<b>DOCKETED</b>	
<b>Docket Number:</b>	23-AFC-01
<b>Project Title:</b>	Morton Bay Geothermal Project (MBGP)
<b>TN #:</b>	254968
<b>Document Title:</b>	Morton Bay PDOC Comments and Exhibit A
<b>Description:</b>	N/A
<b>Filer:</b>	Alisha Pember
<b>Organization:</b>	California Unions for Reliable Energy
<b>Submitter Role:</b>	Intervenor
<b>Submission Date:</b>	3/11/2024 3:59:56 PM
<b>Docketed Date:</b>	3/11/2024

Re: **California Unions for Reliable Energy's Comments on Preliminary Determination of Compliance for the Morton Bay Geothermal Power Generation Plant**

**Subject: Comment Letter Morton Bay Geothermal Project Preliminary  
Determination of Compliance (PDOC)**

**Figure 5:** Geothermal Projects in Imperial County

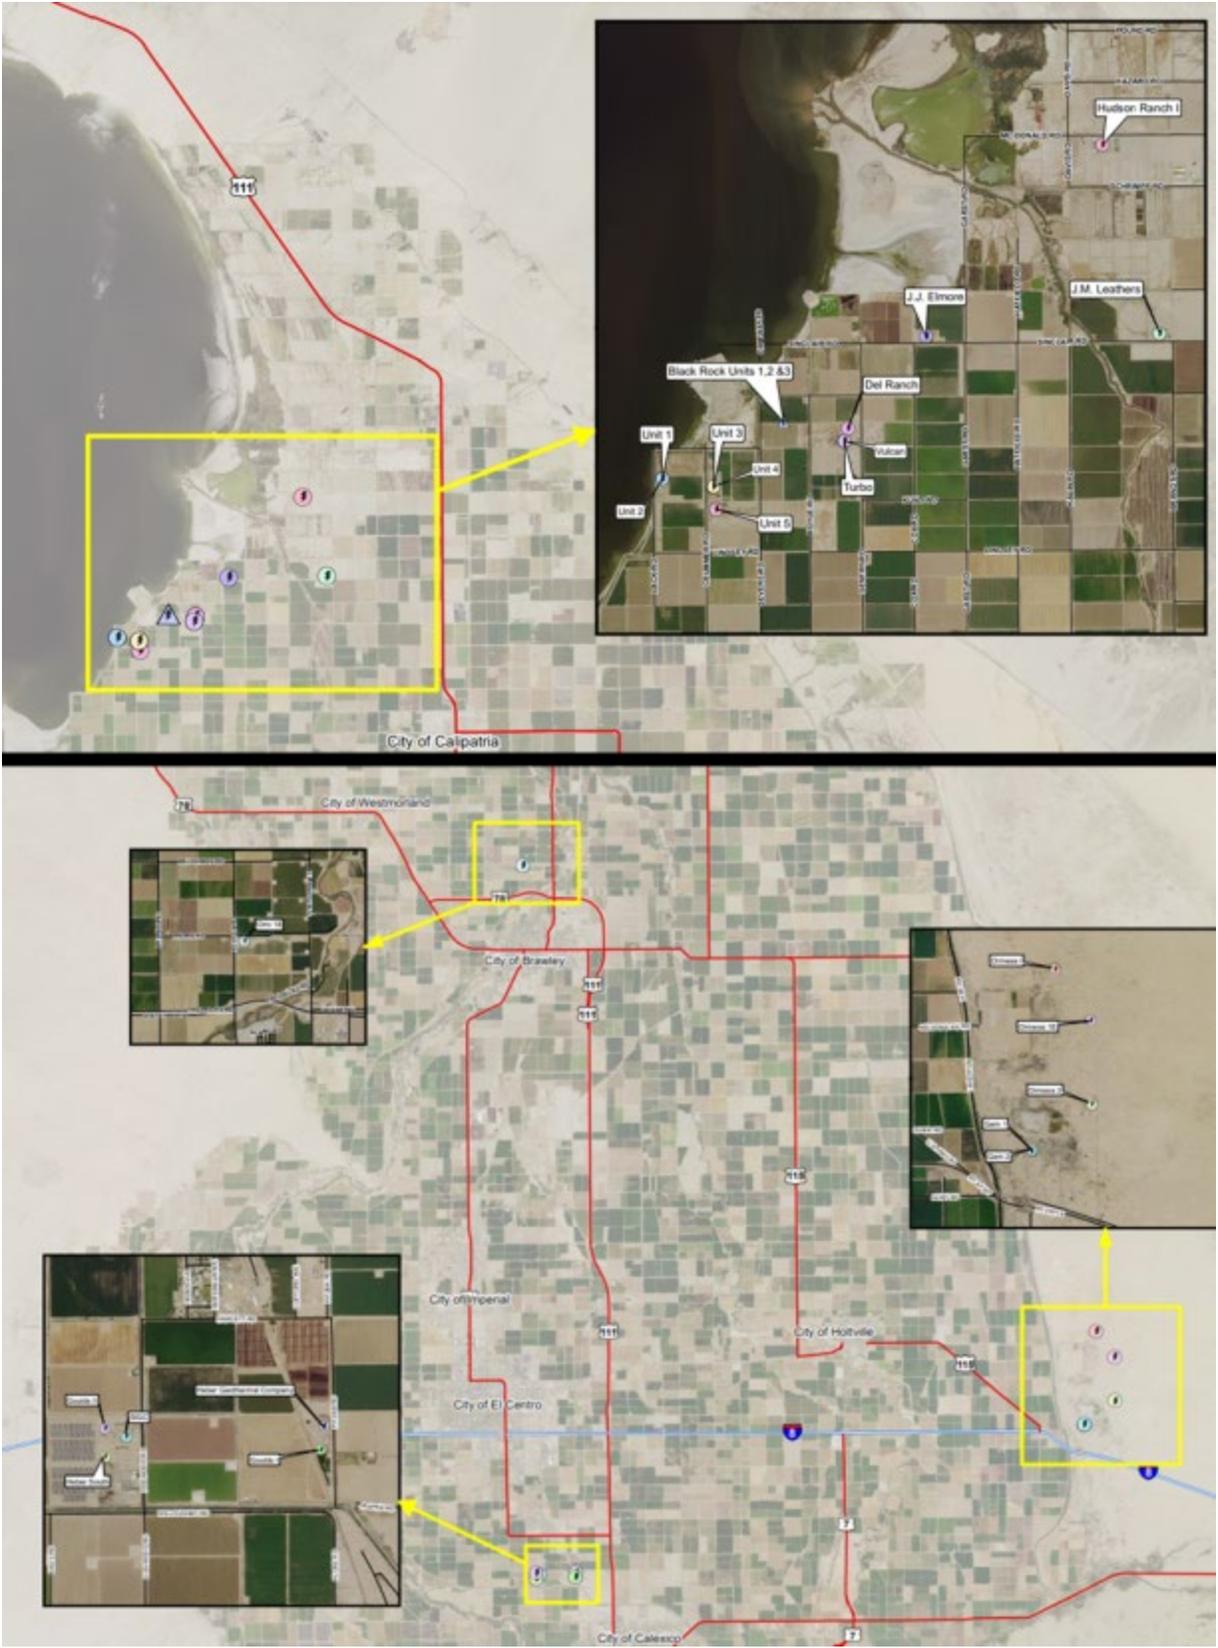
The PDOC falls short in its air quality analysis by omitting a crucial consideration—the emissions from operational geothermal facilities near the Morton Bay Geothermal Project (MBGP). Notably absent from the cumulative emission evaluation are emissions from the CalEnergy Salton Sea Units 1 & 2/3&4/5 facilities, CalEnergy JM Leathers Facility, CalEnergy Central Services facility, CalEnergy Vulcan/Del Ranch facilities, and the existing CalEnergy JJ Elmore Facility<sup>11</sup> (Figure 5 and Table 2). The oversight extends to the exclusion of criteria pollutants (NO<sub>x</sub>, SO<sub>x</sub>, PM, CO, lead) and air toxins (VOCs, including benzene, toluene, diesel particulate matter, etc.) from the comprehensive assessment.

**Figure 6:** Spatial Overview of the Applicant's Three Geothermal Projects - Elmore North Geothermal Project (ENG), Black Rock Geothermal Project (BRG), and Morton Bay Geothermal Project (MBG)

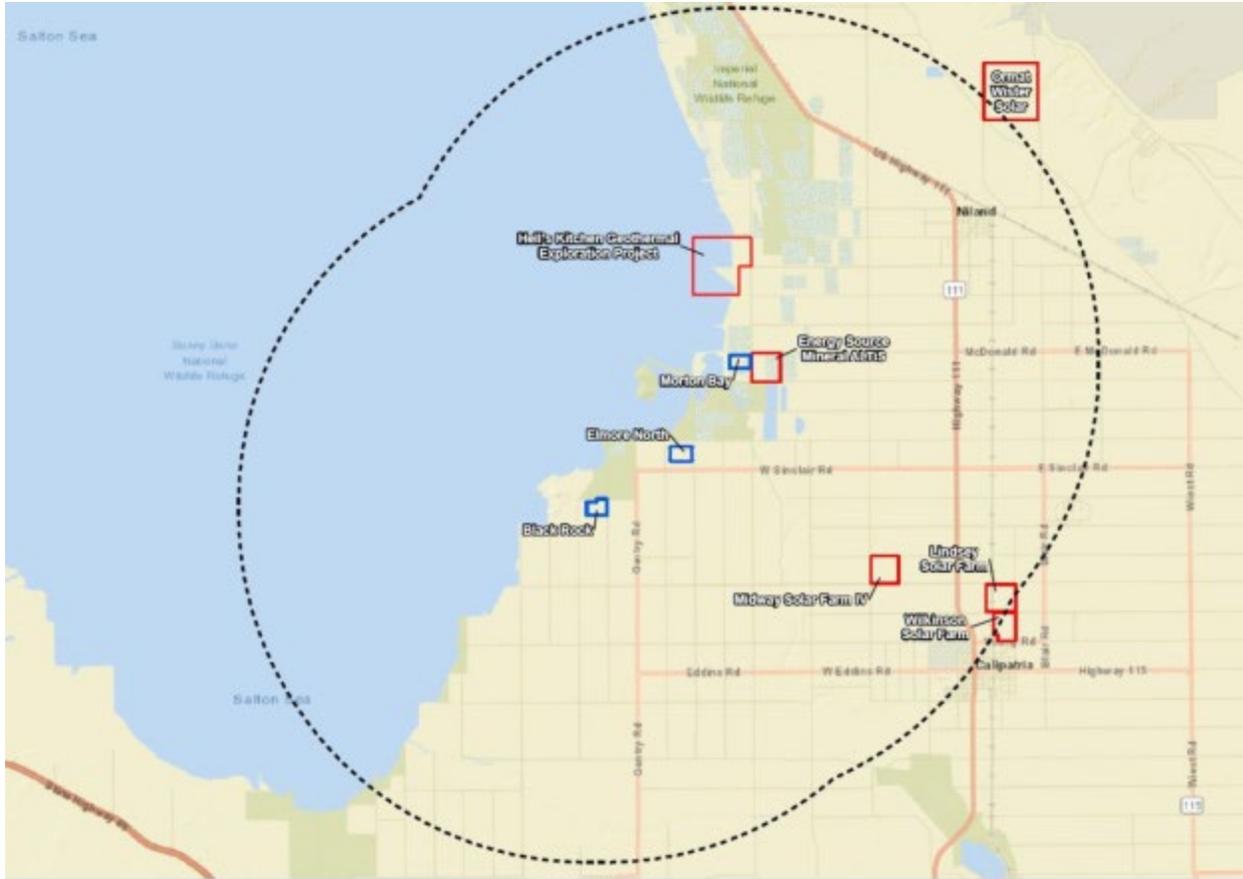
The PDOC fails to account for the cumulative impact arising from both existing geothermal projects and other proposed ventures by the Applicant in the immediate vicinity of the Morton Bay Geothermal Project (MBGP). Notably, the operational geothermal projects and the Applicant's additional proposed developments, namely the Elmore North Geothermal Project and the Black Rock Geothermal Project, are situated near the MBGP (Figure 6). The absence of an integrated evaluation considering these coexisting projects raises significant concerns about the overall completeness and accuracy of the environmental impact assessment. Emissions from the three projects were quantified separately and have not been combined to determine the cumulative impacts on the surrounding community. The potential cumulative effects on air quality, emissions, and overall environmental health may be significant and necessitate a comprehensive analysis that encompasses the combined influence of all geothermal activities in the region. Addressing this oversight in a revised PDOC is paramount to ensuring a thorough understanding of the cumulative environmental impact of geothermal projects in the area.

**Figure 7: Monitoring Stations Identified In Application**

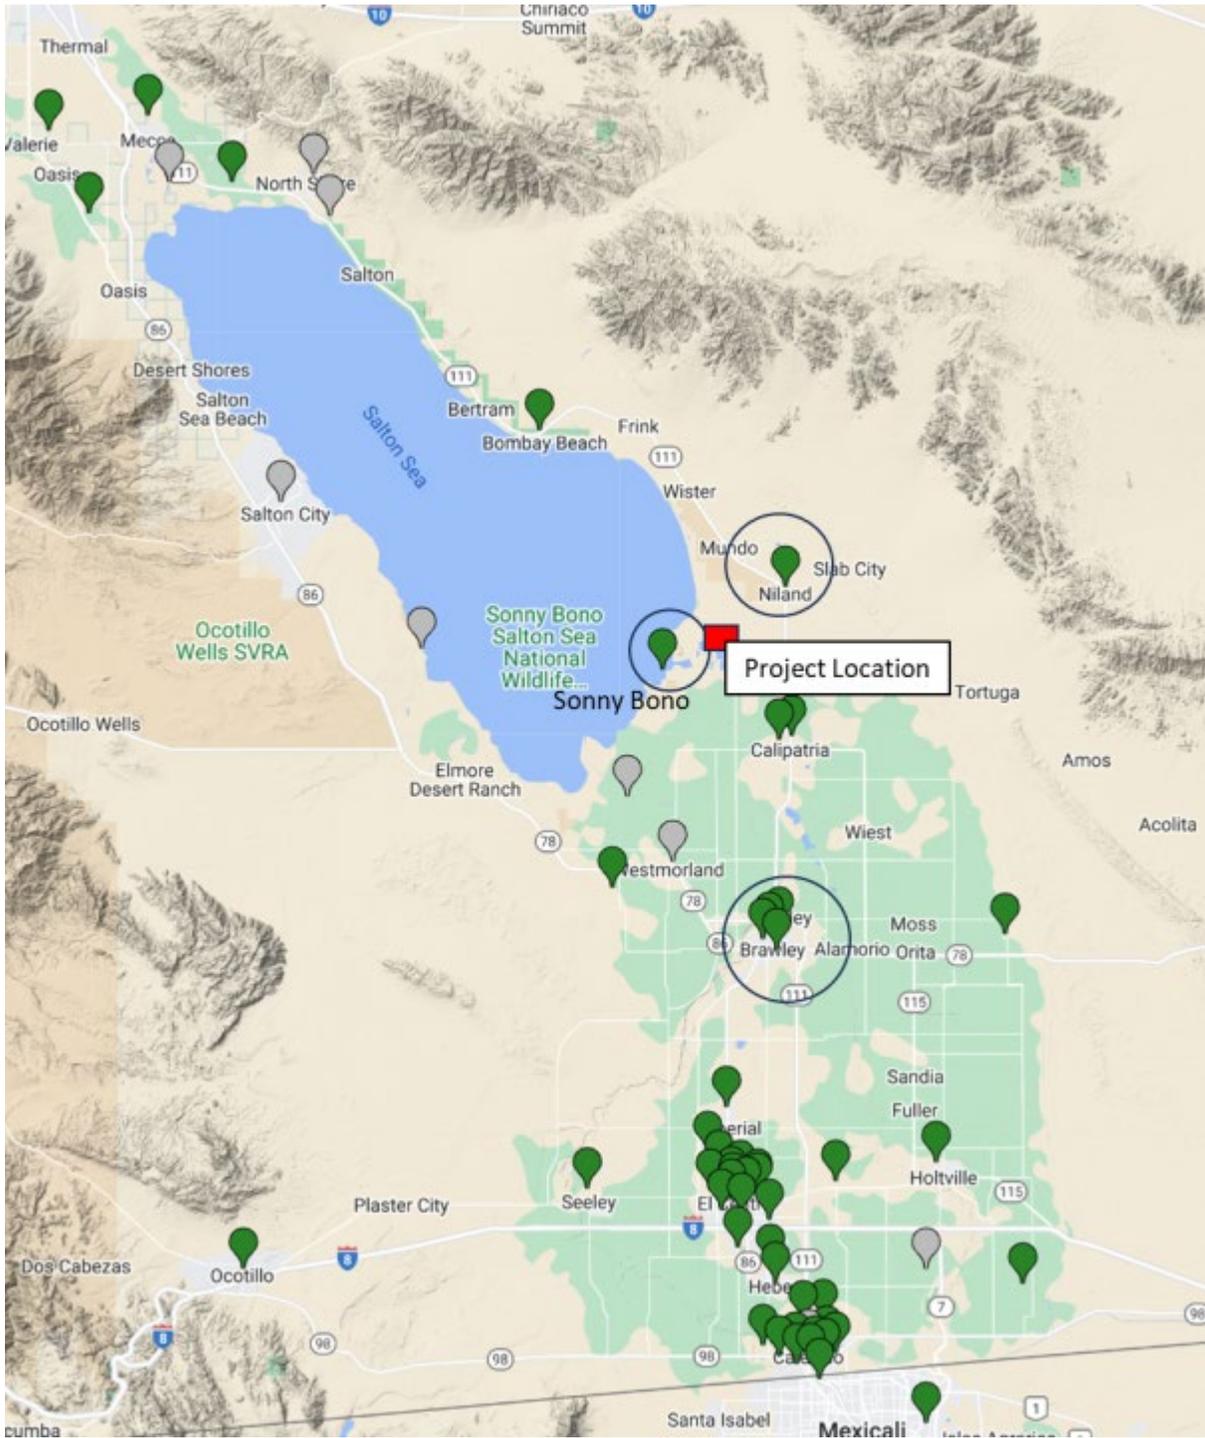
Furthermore, the selection of monitoring stations for PM<sub>10</sub> and PM<sub>2.5</sub> concentrations, such as Niland-English Road and Brawley-220 Main Street, respectively, raises serious concerns about the representativeness of the chosen locations (Figure 7 and Figure 8)<sup>12</sup>. A more comprehensive and critical approach would utilize background concentration values from the Sonny Bono station, which not only is in closer proximity but also covers the more recent years of 2021 and 2022, thereby providing a more accurate depiction of current background pollution levels.

The application also neglects to acknowledge the existence of 40 additional monitoring stations currently active in Imperial County. Information available on the Identifying Violations Affecting Neighborhoods (IVAN) website reveals that the IVAN Air Monitoring network consists of 40 air monitors strategically placed throughout Imperial County. As of September 2016, all but 7 of these monitors have been successfully installed. Figure 5 illustrates the locations of the 13 closest IVAN stations to the Project Site. The applicant should include all relevant monitoring sites in the background analysis of air quality to ensure that background concentrations are accurately reported for the region.

**Figure 9:** 2023 Air Quality Concentrations of PM<sub>2.5</sub> and PM<sub>10</sub> at Sonny Bono

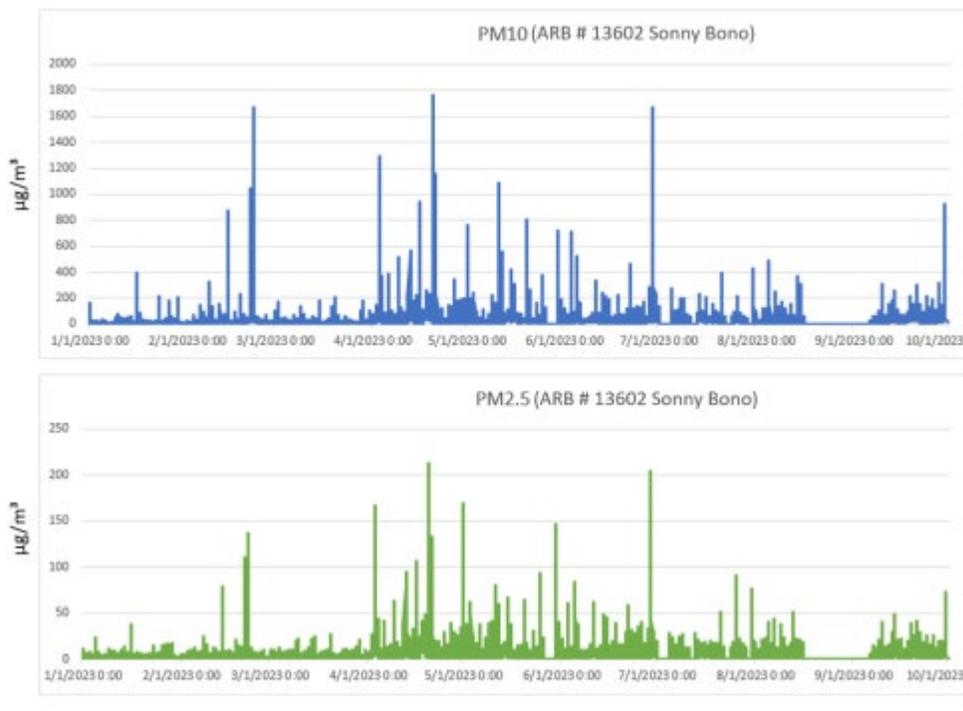
In essence, the discrepancies in the choice of background concentrations and monitoring stations (Table 3), particularly the neglect of the more pertinent Sonny Bono data, see 2023 particulate matter concentrations in the figure below (Figure 9), introduce uncertainties into the accuracy and reliability of the air quality permit application. A meticulous review and reconsideration of these factors are imperative for a more robust and defensible assessment of the Project's environmental impact.

**Figure 11:** Wind Rose Plot Illustrating Wind Conditions at Imperial County Airport Monitoring Station

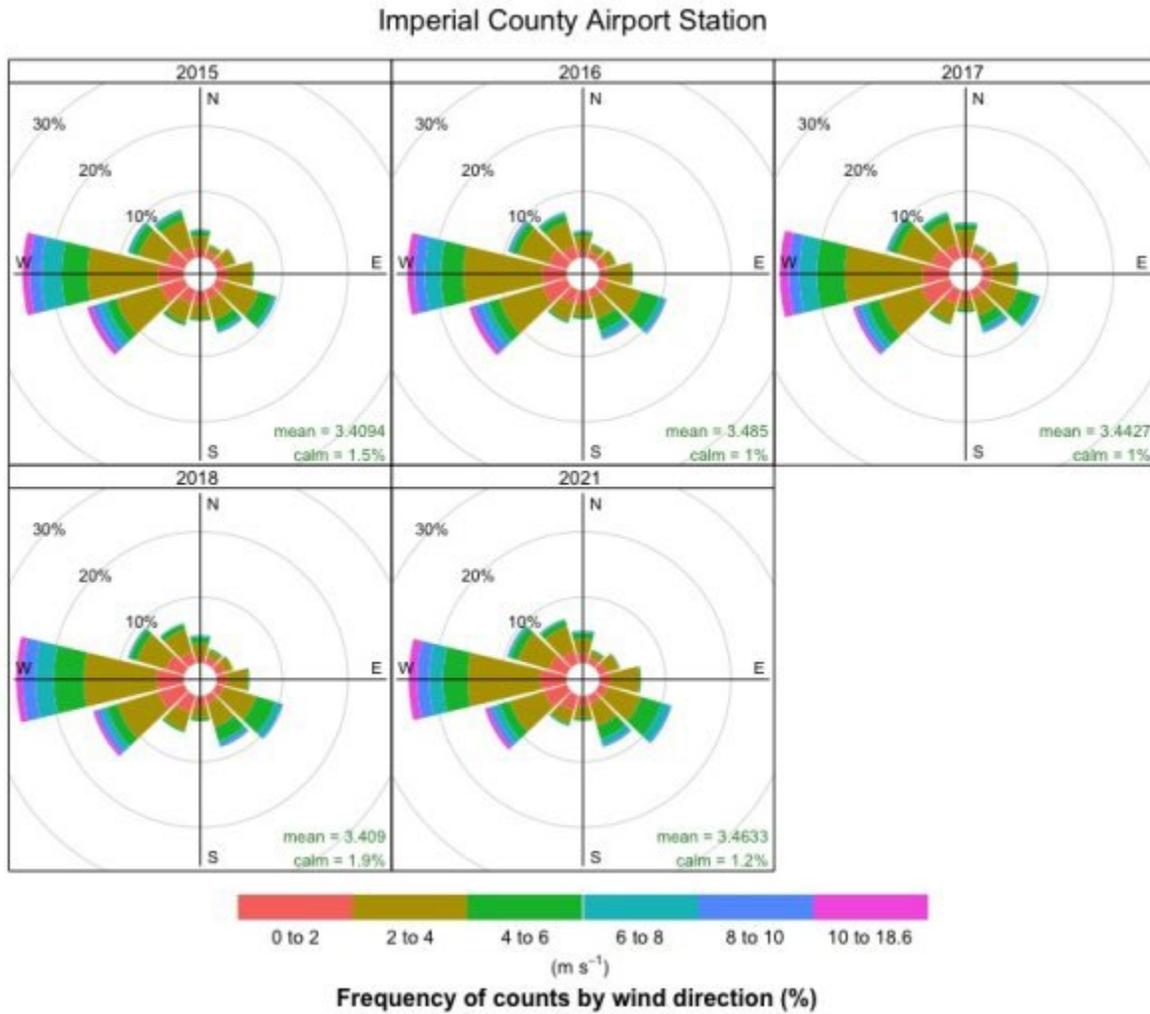
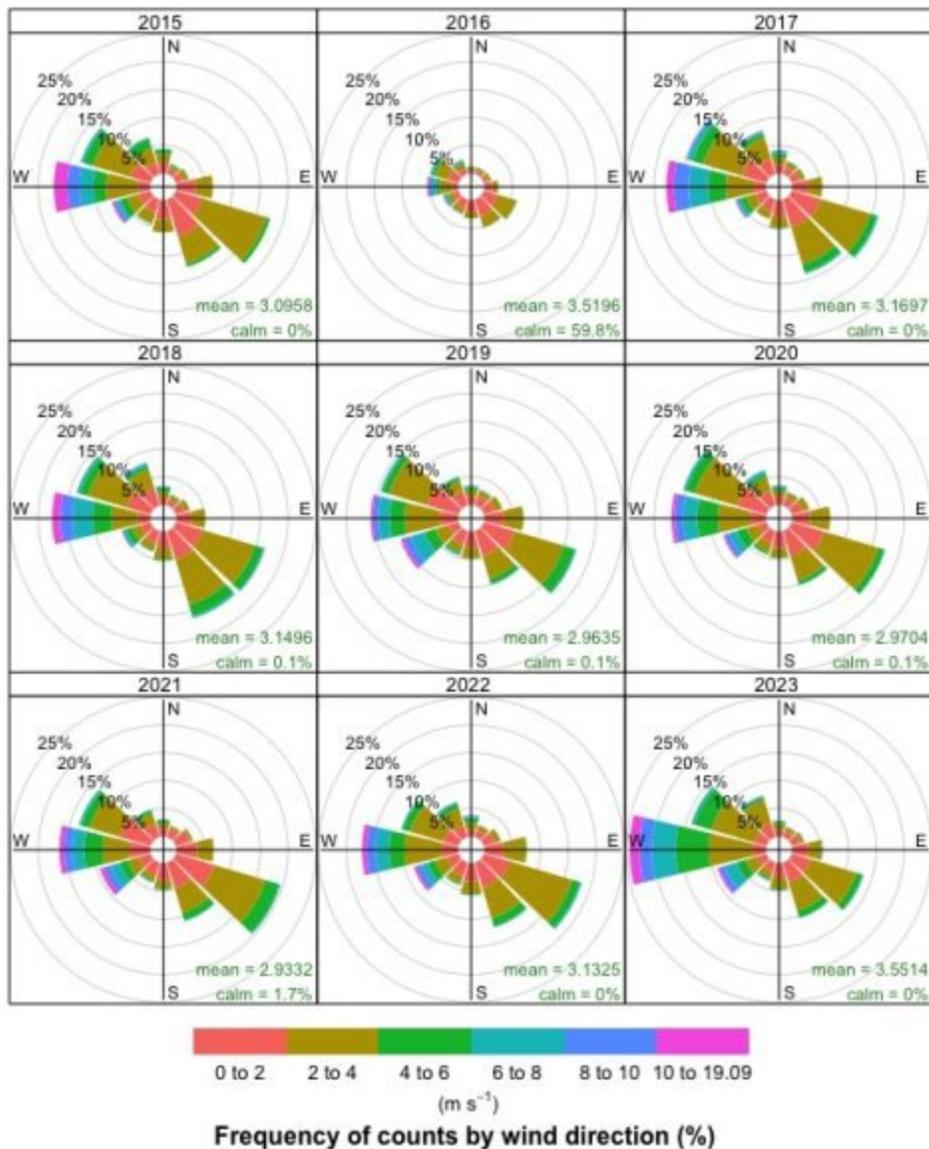
The examination of wind speed, elucidated through wind rose plots for both KIPL and Sonny Bono stations (Figure 11 and Figure 12), is pivotal for understanding the atmospheric dispersion patterns. Notably, KIPL registers an average wind speed of 3.4 m/s, marginally lower than Sonny Bono's 3.51 m/s. However, the key differentiator lies in the prominent wind directions at these locations, with Imperial exhibiting notably calmer conditions.

By computing dispersion based on a distant met station under low wind speeds, the model fails to accurately represent the actual atmospheric behavior, thereby compromising the reliability of the entire analysis.
